PUC PROJECT NO. 57236

COMMENTS ON THE TEXAS	§	PUBLIC UTILITY COMMISSION
BACKUP POWER PACKAGE	§	OF TEXAS
PROGRAM RESEARCH ENTITY	§	
FINAL REPORT

COMMENTS OF  
ALISON SILVERSTEIN CONSULTING

**Texas LDC service territories [per [Texas Railroad Commission](#)]**

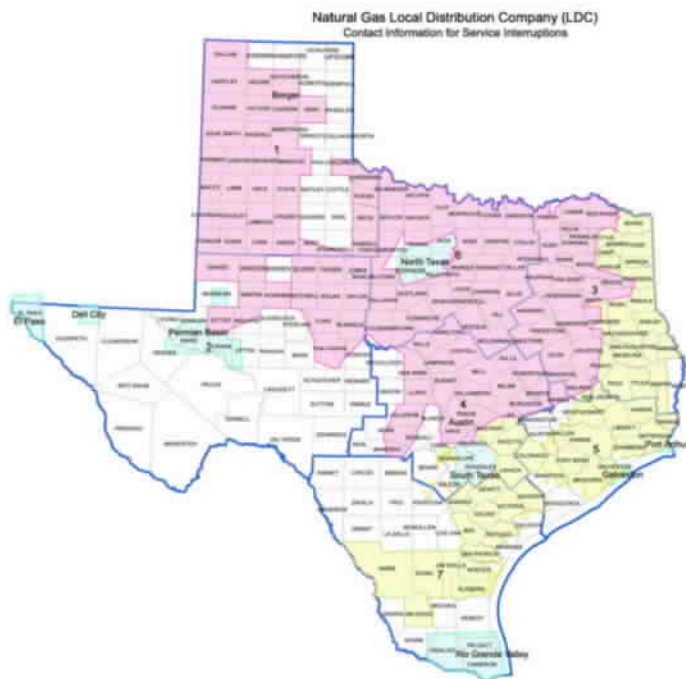
- 4) **Fuel flexibility** -- The Final Report follows the statutory language to specify that the gensets must be natural gas or propane-fired. However, there are areas of Texas that have no natural gas local distribution (LDC) service, so methane-fired gensets will not be an option in those locations.

Solution – The Commission should consider whether it is feasible to expand the set of TBPP-eligible fuels to include clean diesel and biogas, to create more options for CFs in the areas of Texas without access to natural gas LDC service. CFs in natural gas-limited locations may also need help with on-site fuel storage funding and permitting.
